***Application for Amendment of USNRC Source Materials License
SUA-1601, Ross ISR Project, for the
Kendrick Expansion Area***

***RAI Question and Answer Responses for the
Kendrick Expansion Area Environmental Report
Docket #40-09091***

Prepared by:
Strata Energy, Inc.
1900 W. Warlow Drive, Bldg. A
P.O. Box 2318
Gillette, WY 82717-2318

August 2016

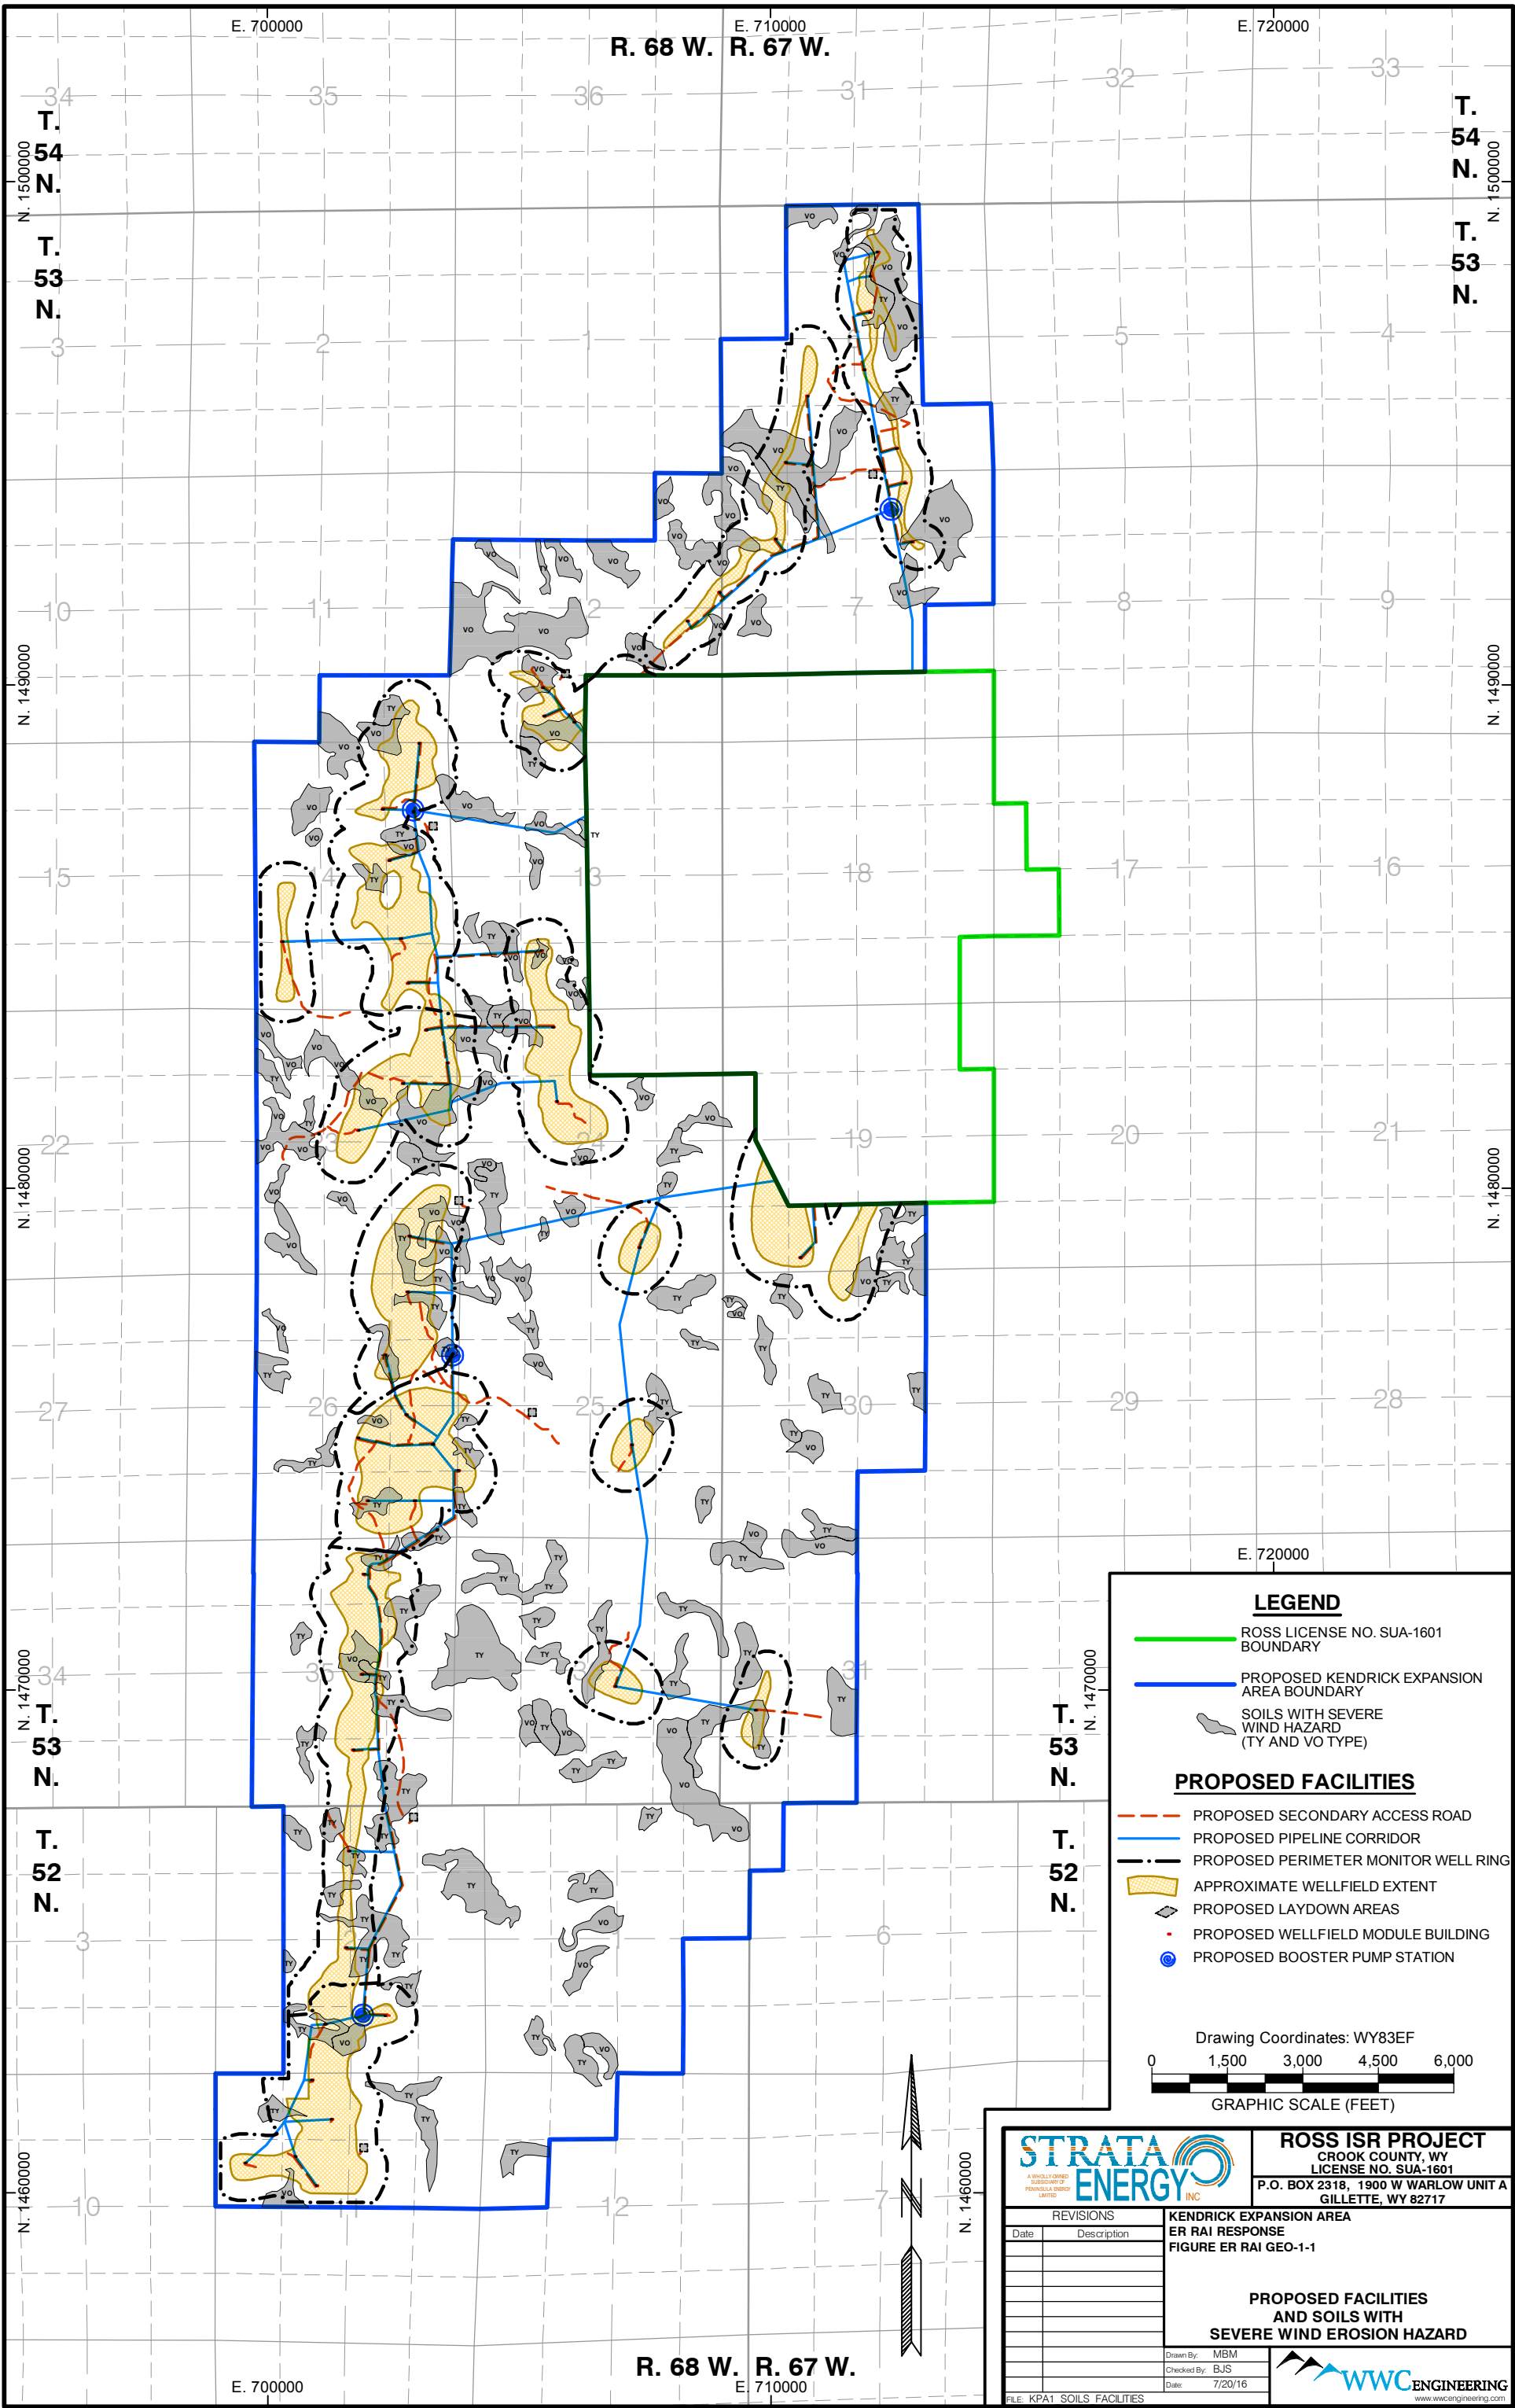
Kendrick ER Section 3.3.5.2 discusses the results of the Kendrick soil survey. Provide additional information based on Addendum 3.3-D to support the discussion on erosion (p. 3-50), better detailing, topographically, where the hazard for wind and water erosion is severe, as stated in ER Section 3.3.5.2, and whether this area is to be disturbed as part of the activities proposed for Kendrick.

Kendrick ER Addendum 3.3-D, Table A.3 indicates that there are two soil types within the proposed KEA with a severe hazard for wind erosion (Terry fine sandy loam [TY] and Vona fine sandy loam [VO]). None of the mapped soil units has been identified as having a severe hazard for water erosion. Figure ER RAI GEO-1-1 overlays the proposed KEA facilities onto the mapped TY and VO soil units. As indicated in Table A.1 of Kendrick ER Addendum 3.3-D, the TY and VO soil types make up 8.2 and 8.3 percent of the proposed KEA, respectively. Based on the information shown in Figure ER RAI GEO-1-1, the anticipated amount of disturbance in the TY and VO soil types is 69 and 76 acres, respectively.

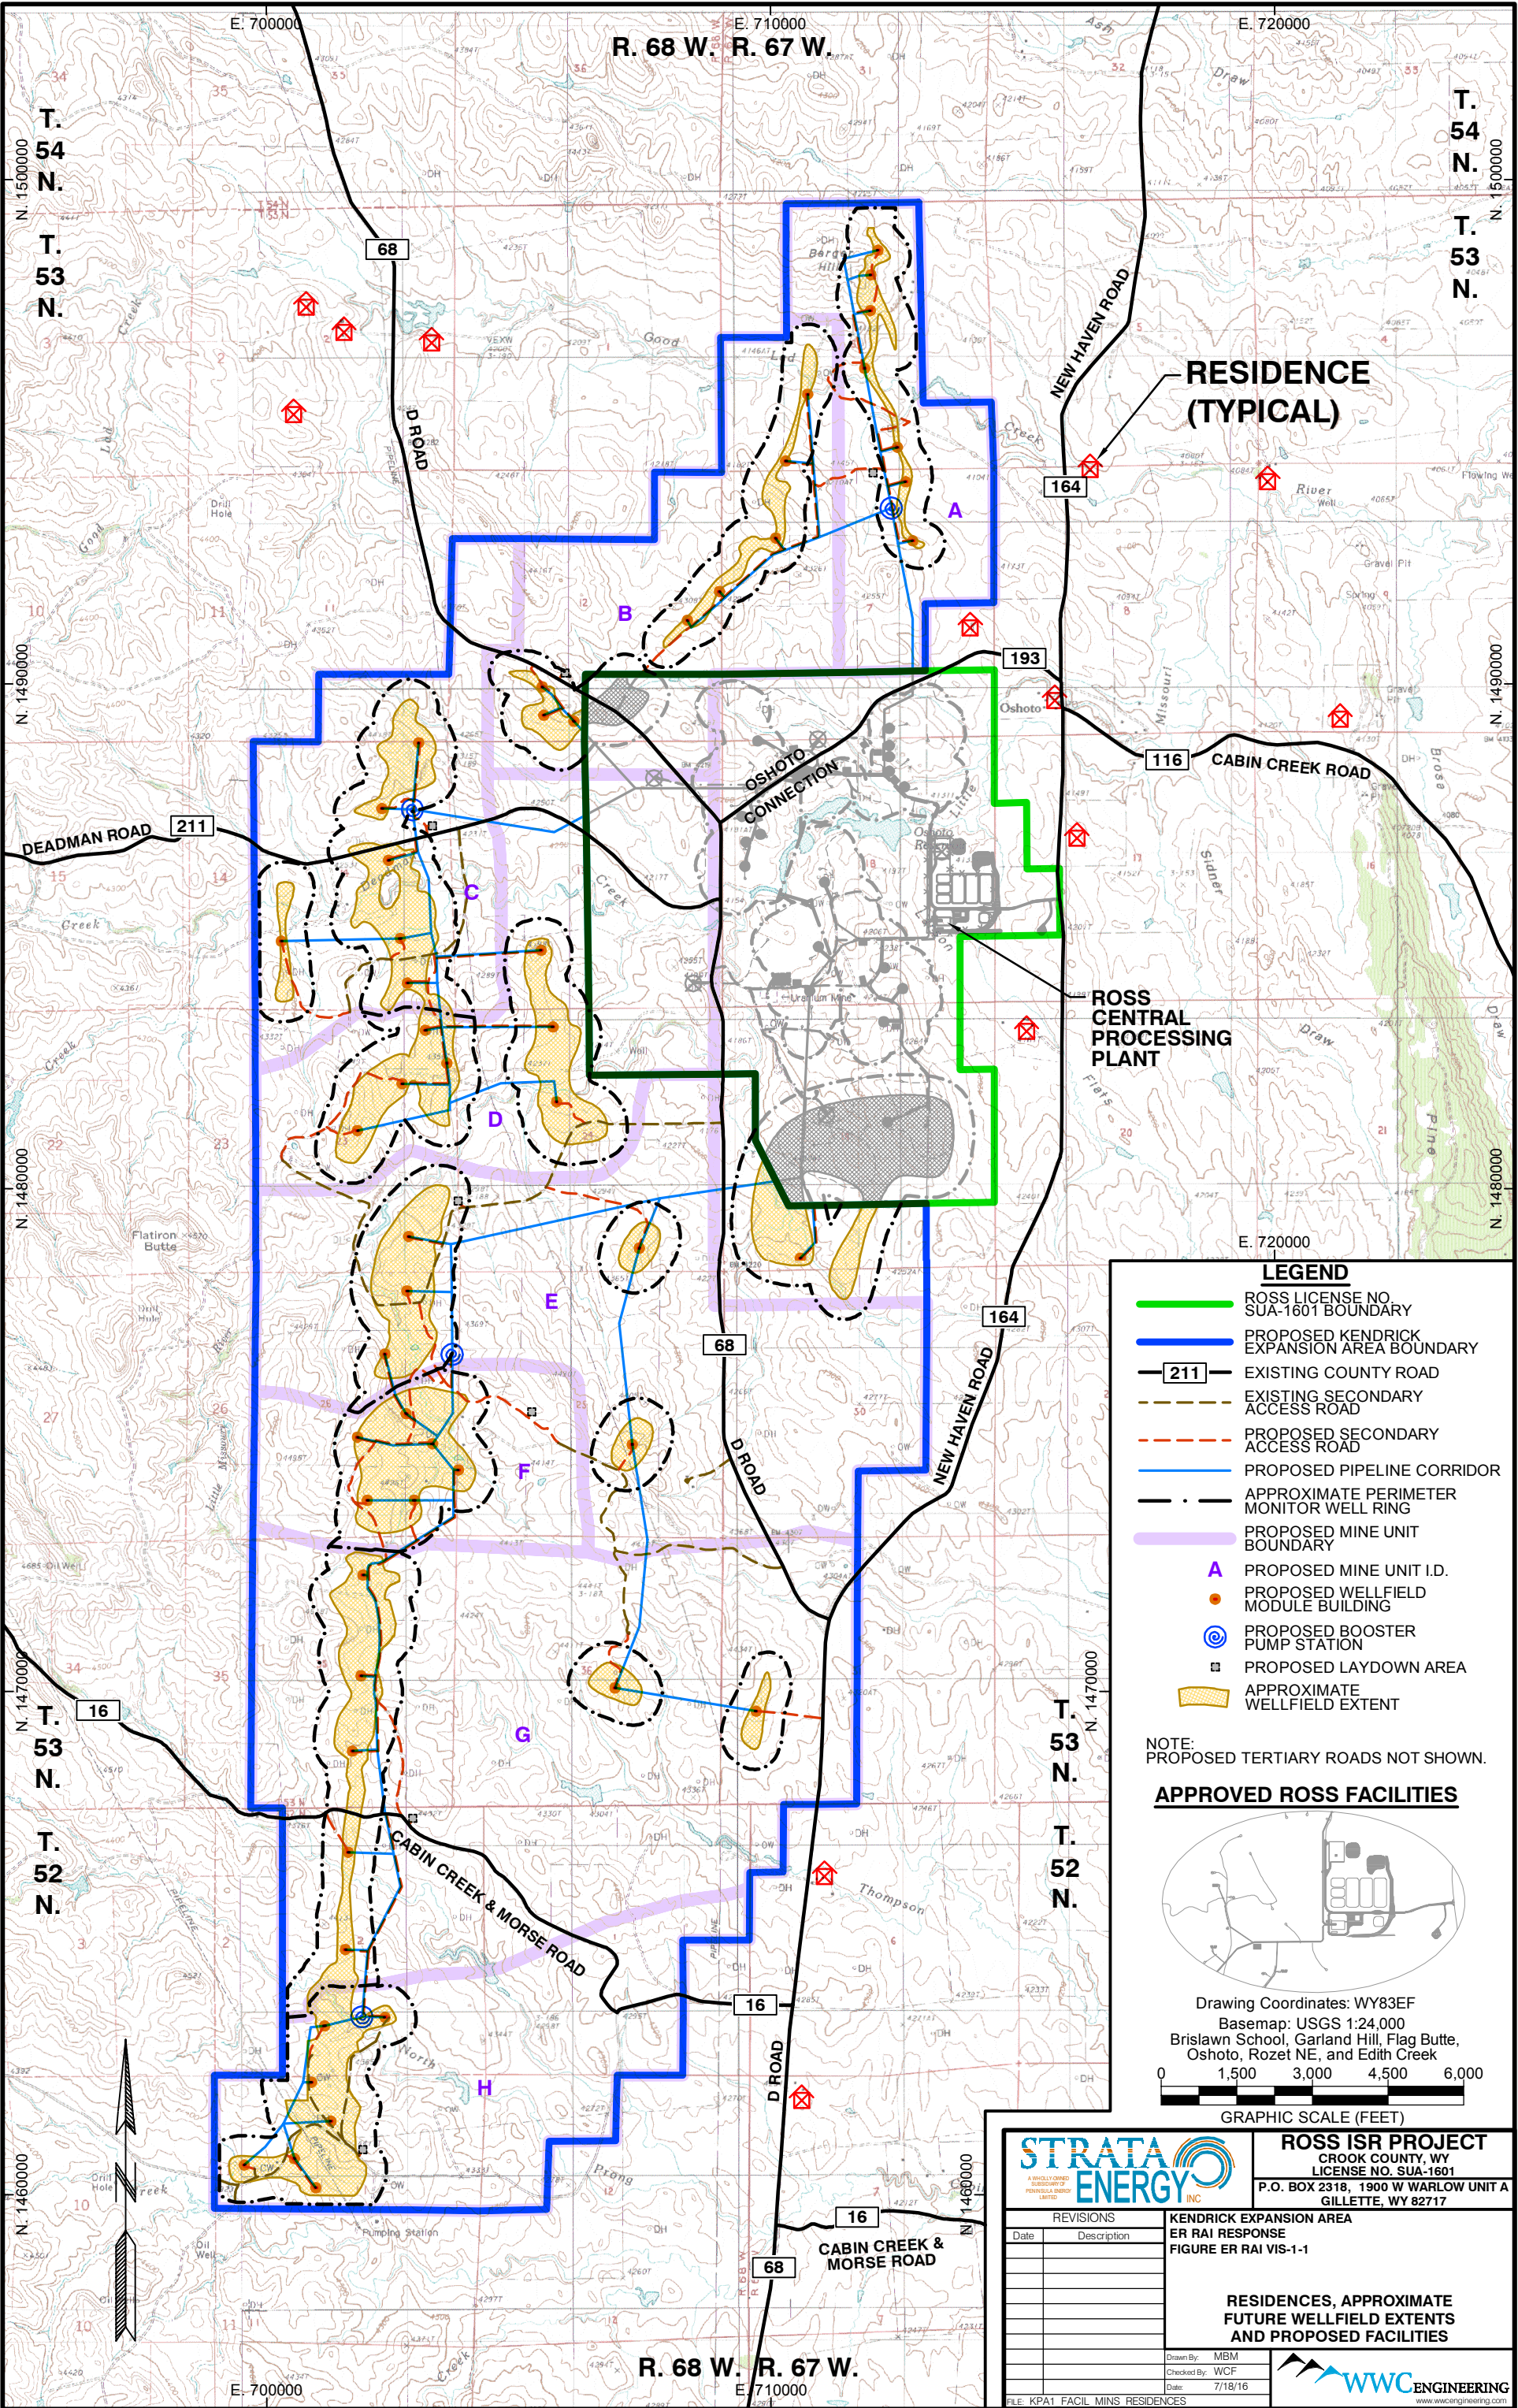
The Kendrick ER and TR do not seem to include specific analysis of Kendrick activities and their visual impact on residences. Provide information on the Kendrick activities that would be visible from existing residences and mitigative steps being taken (such as painting schemes and solicitation of input from stakeholders).

Proposed project facilities (from Kendrick ER Figure 2.1-1) and nearby residences (from Kendrick ER Figure 3.1-4) are depicted on Figure ER RAI VIS-1-1. Distance and topography will limit the visibility of project activities from the residences, and the
